Planning Decisions Committee

6.30pm, Wednesday 20 January 2021

1. This report provides Council with an assessment of planning permit application PLN20/0037 which is for the construction of a six-storey building, with a reduction in the car parking requirements associated with the use of the land as a food and drink premises (cafe) and as-of-right office at Nos. 25 Balmain Street & 128 - 134 Cubitt Street Cremorne & Laneway TP938653J Cremorne VIC 3121. The report recommends approval of the application, subject to conditions.

S57 Plans: Balmain Street Frontage (Jackson Clements Burrows Architects October 2020)

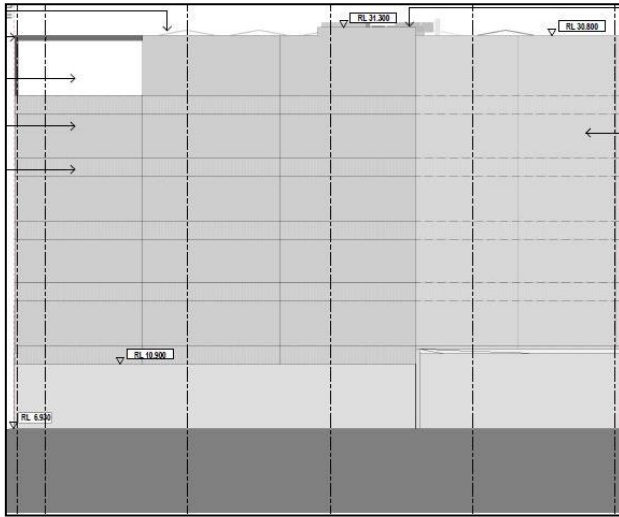
118. Based on the advertised plans, Council’s Urban Design Unit found the ratio between blank wall/services area and glazing at ground floor unacceptable. Therefore, in order to provide a more active street frontage, the applicant revised the ground floor treatment as part of the S57A submission; with the extent of glazing along Balmain Street increased compared to the advertised plans (see image below showing the comparison highlighted in pink and blue).

117. As part of the S57A submission, the applicant provided all of the above requirements. The plans now show the extent of pavers to be located within the title boundaries of the subject site, with the footpath beyond to consist of asphalt.

S57 Plans: Northern Façade (Jackson Clements Burrows Architects October 2020)

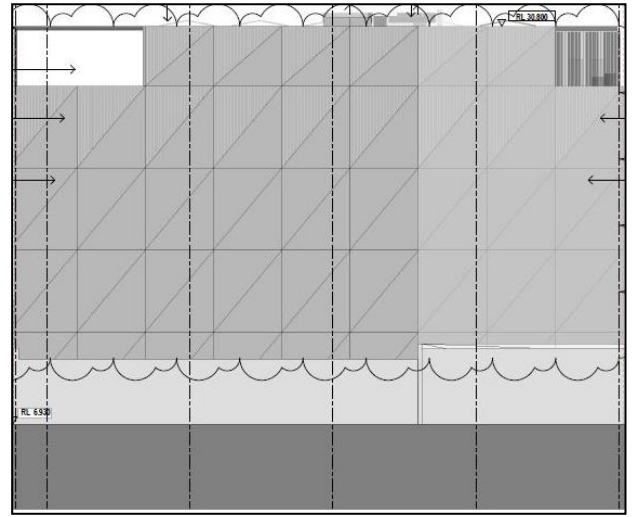
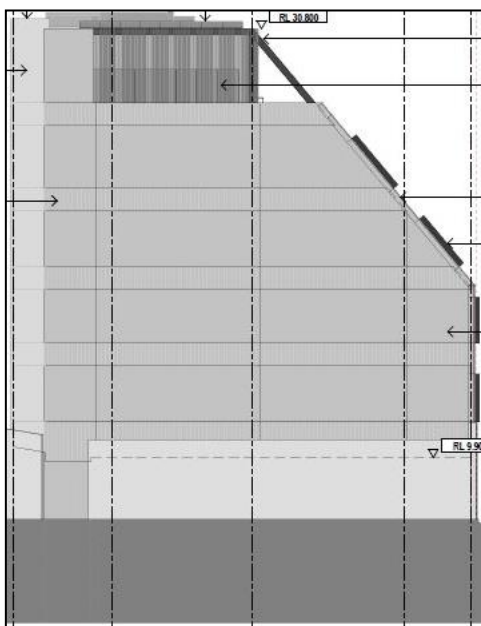
127. Council's Urban Design Unit found *the large expanses of blank wall along north and west facades will make the form appear more bulky from street views*. Whilst such material treatment has been proposed in order to ensure equitable development opportunities of adjacent sites, Council's Urban Design Unit recommended that *till those sites are developed these walls will be very visible from the surrounding areas and therefore, to provide some level of articulation or design or texture on these blank walls so the development does not detract from the fine grain character of the streetscape when viewed from oblique views*.

128. As a result, under the S57A submission, the applicant altered the previously proposed horizontally applied patterned and ribbed concrete to a diagonally patterned mix of concrete and ribbed concrete to the northern and western facades (see images below). This is an important feature of the design as it will reduce visual bulk impacts to nearby properties but also because it will ensure that the side boundary walls (which will be highly visible from the public realm) are aesthetically integrated with the development's overall architectural composition.
